Appendix 1 Planning Conditions and Informatives

Appendix 2 Plans and Images

Stakeholder	Question/Comment	Response
	well laid out for modern life, with open plan living spaces, from which a private balcony is accessed.”	
Conservation Officer	<p><u>“HGY/2021/2075 - Land at the junction of Partridge Way and Trinity Road, London, N22 8DW</u></p> <p><u>The site</u> The application site sits to the north-east of Bounds Green Road, at the junction between Trinity Road and Partridge Way and is currently occupied by a row of single-storey garages. Just north of the site stand two 15-storey post-war tower blocks, Finsbury House and Newbury House.</p> <p>The application site is not within a conservation area and does not include any statutory or locally listed buildings. However, it is located approx. 65m to the south of the Bowes Park Conservation Area and approximately 100m to the north-west of the Trinity Gardens Conservation Area. Wood Green Common Conservation Area extends approx. 260m to the south and south-east of the application site.</p> <p>With the exception of Myddleton Road, which was established as a shopping street by 1900, Bowes Park Conservation Area is almost exclusively re

01 PROPOSED GROUND FLOOR PLAN
103 1:100

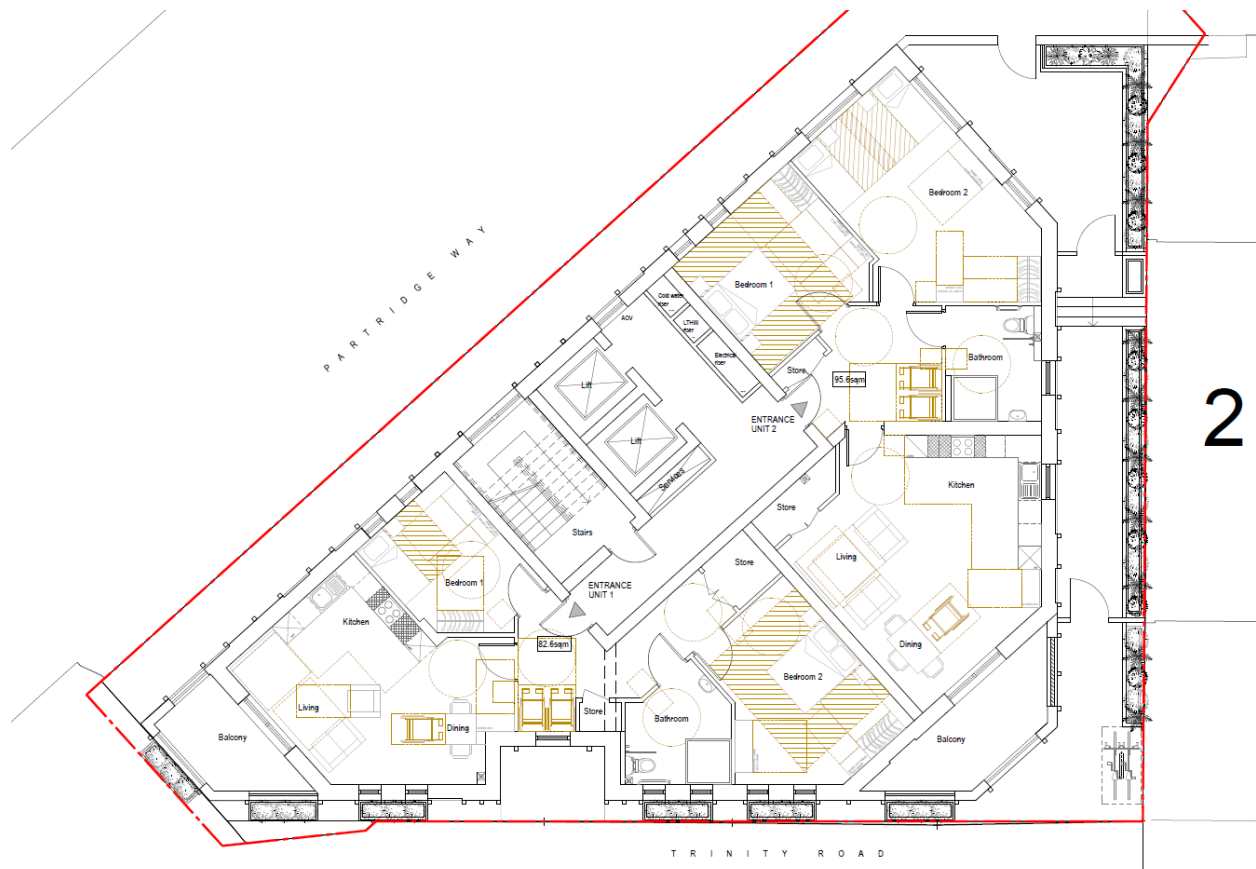
Stakeholder	Question/Comment	Response
	<p>c) Note that after initial submission that there was a request for the bin store to be relocated en-route out of building. Whilst the new location rectifies this, the access to it is through 2 separate doorways from the main entrance area. Officer cannot ascertain what the communal area is (ringed yellow in attachment) but presume the two access doors are a fire regulation requirement? If so, the bin store location is fine.</p> <p>d) The transport statement says "Bins will be within the industry standard bin transfer distance of 15m from kerbside to refuse vehicle". Please note our local specification is within 10m (Haringey Supplementary Planning Document, Appendix A3)</p>	<p>are already bins on-site which require vehicles to manoeuvre in this area. The new bin store would not be significantly further away/re-located with vehicles also in the same area.</p> <p>c) Comments noted. However, they do not acknowledge or comment on the main bin store door which opens directly onto Partridge Way for direct access. This also avoids a 10m+ distance, which itself is guidance rather than a fixed requirement. Applicant to provide further commentary before committee meeting.</p> <p>d) As above.</p>
